**Answers to Environmental and Social Impact  
Review Committee questions in the context of the  
request to amend the certificate of authorization for  
the Parc National Nibiischii project**

Direction des parcs nationaux  
December 10, 2020

**MINISTÈRE DES FORÊTS, DE LA FAUNE ET DES PARCS**

Figure 1 Area difference for the removal of the western sector of the rivière Rupert from the Alouette-Témiscamie-Otish National Park project.

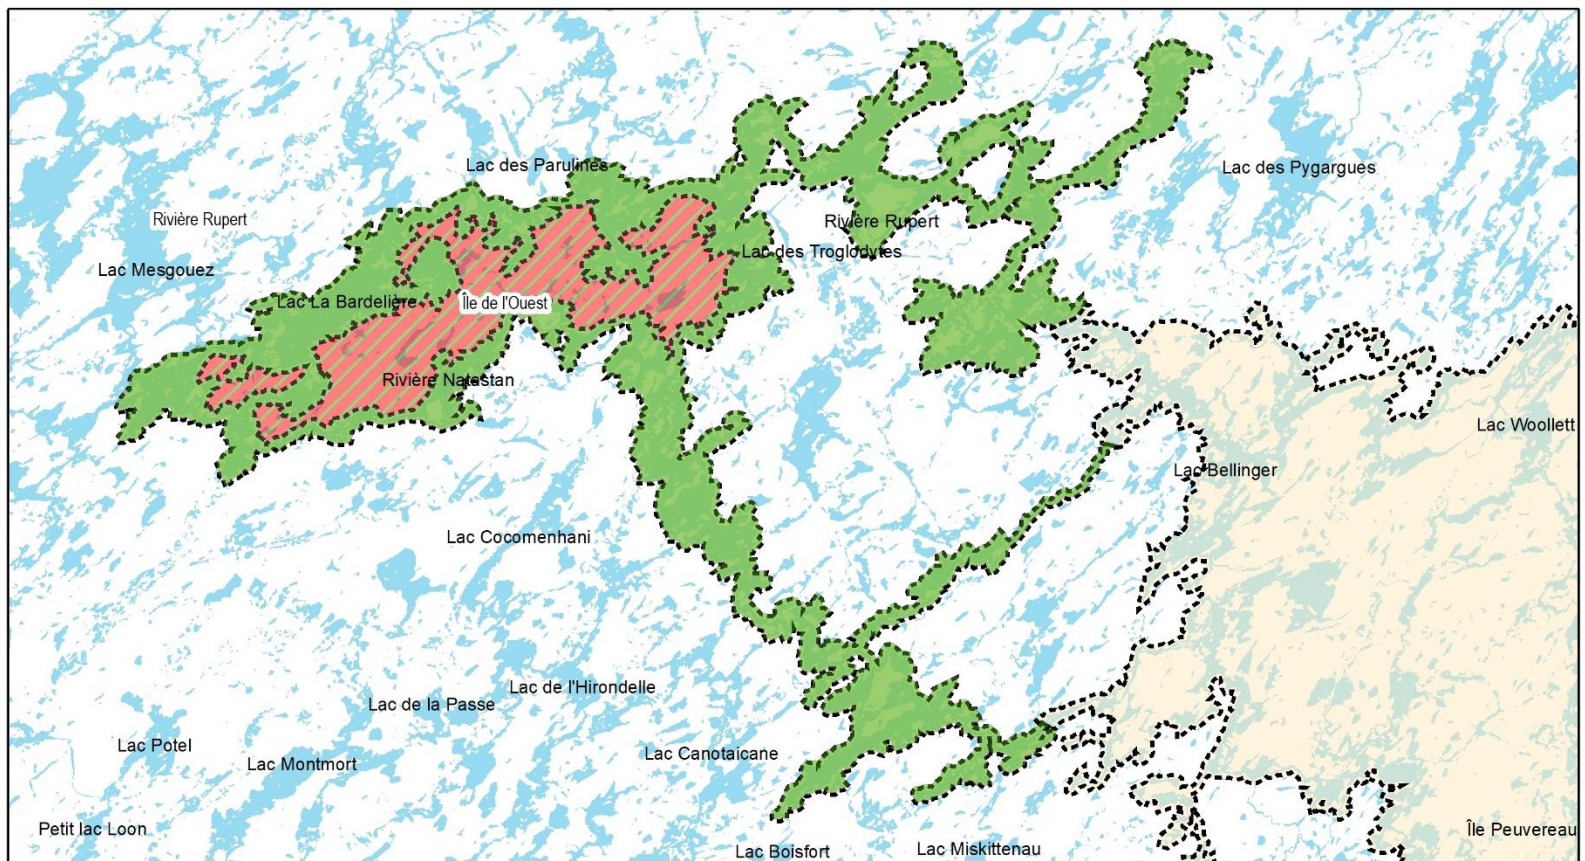
*(1) By calculating the additions and exclusions amending the park project's boundaries, 242 km<sup>2</sup> are missing to reach the total of 11,992 km<sup>2</sup> proposed in the request. The promoter will have to explain this difference.*

In April 2010, the environmental and socio-economic impact study sent to the ministère du Développement durable, de l'Environnement et des Parcs (MDDEP) reported a total area of 12,260 km<sup>2</sup> for the Albanel-Témiscamie-Otish National Park project. Subsequently, on June 6, 2011, a note was sent from Mr. Patrick Beauchesne, Director of Ecological Heritage and Parks, to Mrs. Marie-Josée Lizotte, Director of Environmental Assessments, concerning details regarding the boundary of the national park project (Appendix 1). In this note, it was mentioned that Hydro-Québec wished to remove from the park project a 15 km wide corridor, in the western section of the rivière Rupert, for the possible passage of a power line. Consequently, it had been decided not to include this sector in the proposal for Albanel-Témiscamie-Otish National Park. The area to be excluded from the park project was then estimated at 666 km<sup>2</sup>. Thus, the national park project area decreased to 11,594 km<sup>2</sup>, or approximately 11,600 km<sup>2</sup> as authorized by the CA.

Upon verification, it seems that the area to be excluded from the national park project should have been 423 km<sup>2</sup> instead of 666 km<sup>2</sup>. This difference of 243 km<sup>2</sup> is due to a geomatic error that occurred while calculating the area to be excluded. In fact, the western sector of the rivière Rupert (Figure 1; green polygon) includes an aquatic portion and a land portion, namely the Île de l'Ouest. However, at that time, the Île de l'Ouest was not part of the national park project. Consequently, it would have been necessary to remove only the area occupied by the aquatic portion, i.e. 423 km<sup>2</sup>. However, in calculating the area to be excluded, the area of the Île de l'Ouest (Figure 1; red polygon with green lines, ~ 121 km<sup>2</sup>) was not subtracted from the polygon to be removed; it had actually been added. Thus, the national park project area, for which a certificate of authorization was issued in 2011, should have added up to approximately 11,830 km<sup>2</sup>.

Figure 2 Changes to the boundaries of the Parc National Nibiischii project between 2011 and 2013.

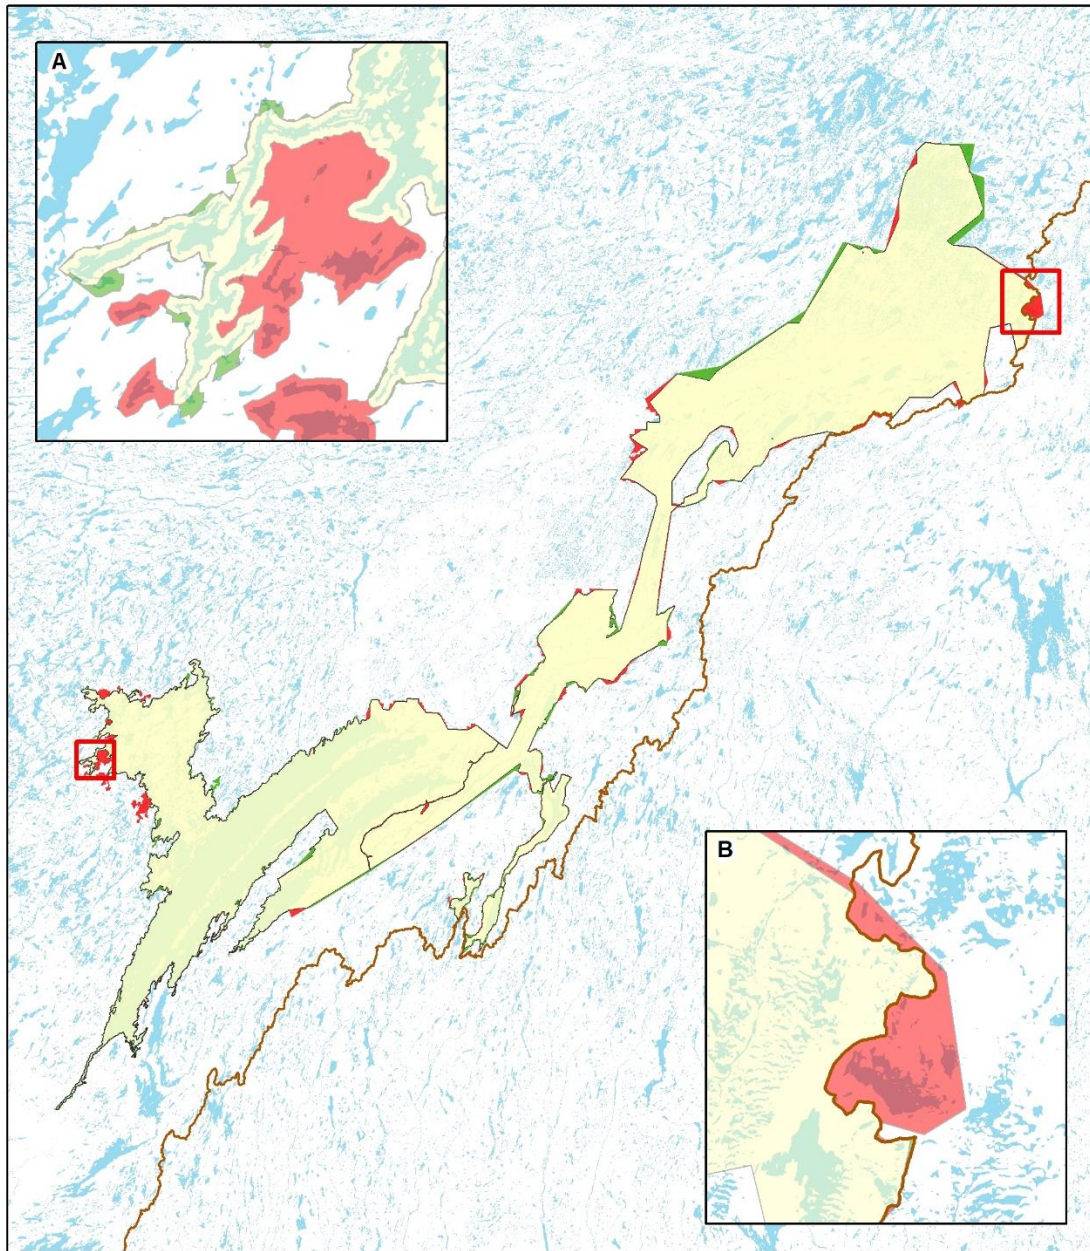
*The details that have been provided by the promoter do not allow to target all the proposed additions. The promoter must further detail the difference in park area between the 2011 request and this amendment request. He must provide a map comparing the 2011 boundaries and the proposals in this request.*

Figure 2 illustrates the Parc National Nibiischii project boundary changes between 2011, when the certificate of authorization was issued, and 2013. In order to determine a boundary that takes into account the various geographical points that can be identified, the Bureau de l'arpenteur général du Québec (BAGQ) uses a technique that attempts to fit the proposed boundaries. However, since the surveyors must draw straight lines, this technique can add and remove certain parts of the proposed national park territory. In addition, the accuracy of the mapping has been improved from 1/250,000 to 1/50,000. This has clarified the contours of the lakes and rivers and thus changed the boundary, which sometimes includes a buffer zone of 200 m around bodies of water. Figure 2A shows that some bodies of water, once considered part of the western section of the rivière Rupert, are in fact separate lakes that are not part of the proposed national park territory. The southeastern boundary of the national

park project also follows the James Bay and Northern Quebec Agreement (JBNQA) boundary, which subtracts the territories claimed by the Innu Nation (Figure 1B).

Figure 3 Changes to the boundaries of the Parc National Nibiischii project between 2013 and 2020.

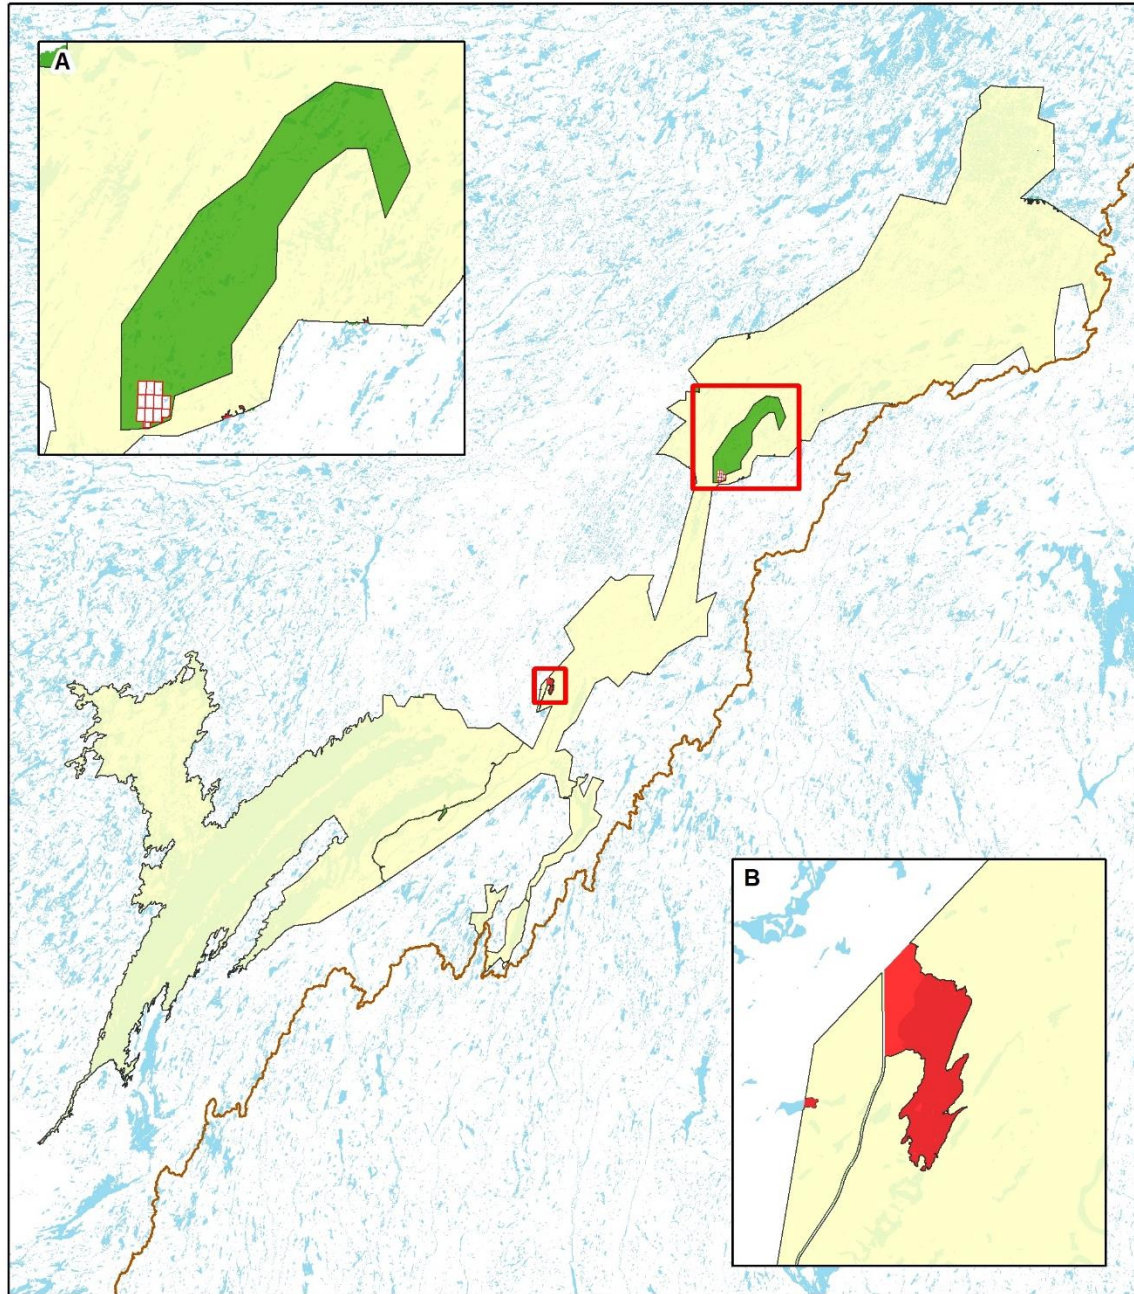
*There is a slight difference between the area mentioned on page 11 of the amendment request (11,992 km<sup>2</sup>) and the one presented in Table 2 of the amendment request (11,989 km<sup>2</sup>). The promoter must specify the area subject to this request to amend the certificate of authorization.*

*Following the suspension of the granting of mining claims in the monts Otish sector, an area of 155 km<sup>2</sup> was added to the park project. Map # 7 of the request shows this area identified by a pink hatch. However, a small area to the south is not hatched, and this suggests that an enclave (donut hole effect) still exists in this area. This area is not identified as having active mining titles.*

Figure 3 illustrates the changes to the boundary of the Parc National Nibiischii project between 2013 and 2020. We mainly note the addition of a territory in the upstream part of the rivière Témiscamie (figure 2 A) and the withdrawal of lac Roxane (figure 2B). In addition, four gravel pits were added to the national park territory following their restoration in 2014. Finally, minor adjustments were made to the park boundary to include or exclude certain lakes in order to facilitate the management of the territory.

There were some inaccuracies in the area calculation. Indeed, the area of 11,992 km<sup>2</sup> includes nine mining claims (total of around 6 km<sup>2</sup>; Figure 3A) that are still active and are not included in the Parc National Nibiischii project. In addition, the adjustment of Category II land (0.41 km<sup>2</sup>) and the adjustments related to the preparation of the boundary to send to the BAGQ had not been included (0.58 km<sup>2</sup>). Thus, the area subject to this request to amend the certificate of authorization is 11,989 km<sup>2</sup> (NAD 1983 Quebec Lambert coordinate system).

The non-hatched zone area shown on map #7 of the request has not been included in the proposed limit because it contains active mining claims held by SOQUEM inc. (Figure 3A). In the event that these mining claims are not renewed when they expire on April 9, 2021, they are going to be integrated within the boundaries of the national park as specified by condition 4 of the certificate of authorization from December 8, 2011. The process that will then be initiated is basically broken down into the following stages:

Figure 4 Update of zoning in the Albanel campsite sector

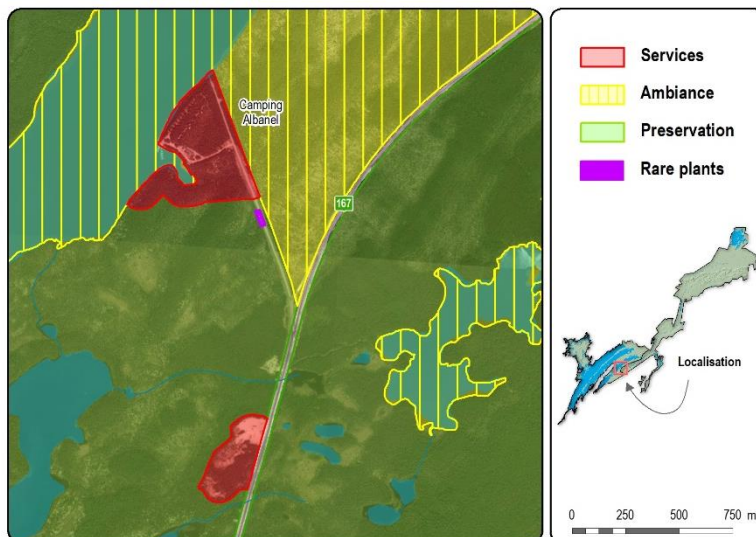
*The promoter indicates that there will be an addition of two new zones in the Albanel campsite sector in order to increase the number of spaces available at this campsite, which is full during the summer. On map 14, there are two new service areas in the sector. However, the campsite area is not expanded. The promoter will have to discuss the justification for the two new service areas in this sector. He will also have to clarify why the current service area is not being expanded.*

There are false mountain willows (*Salix pseudomonticola* C.R. Ball) along the access path to the Albanel campsite. However, no mention is made of the presence of a plantation of false mountain willows in the smaller of the two service zones along route 167 north. It should be noted that this plantation is a mitigation measure that was required by the ministère des Transports du Québec (MTQ), as part of the route 167 North construction project. Moreover, the latter monitors the growth of the plantation in connection with the mitigation measure. In this regard, the MTQ conducted a field inspection on July 31, 2019, which led to an update of the protection limits for false mountain willows. The promoter must indicate the type of development he plans to carry out in this sector's service area. It must also indicate how the plantation of false mountain willows will be protected and how it will take into account the protection limits identified by the MTQ.

There was an error in map 14. The text does refer to an expansion of the south side of the campsite, but the map does not reflect this change. The following map illustrates the proposed zoning change. As a result of this addition, the service area of the Albanel campsite increases from 0.11 km<sup>2</sup> to 0.26 km<sup>2</sup>.

No development is currently planned in this area (see Figure 4). In the area to the south, a remote landfill (reference number 3214-16-078) has been established. Waste and generator oil are being stored there temporarily. The MFFP intends to apply the recommendations of the firm that carried out the inventory in 2018, namely to fence the transplant site and report the presence of this plant species with special status (see report in Appendix 2).
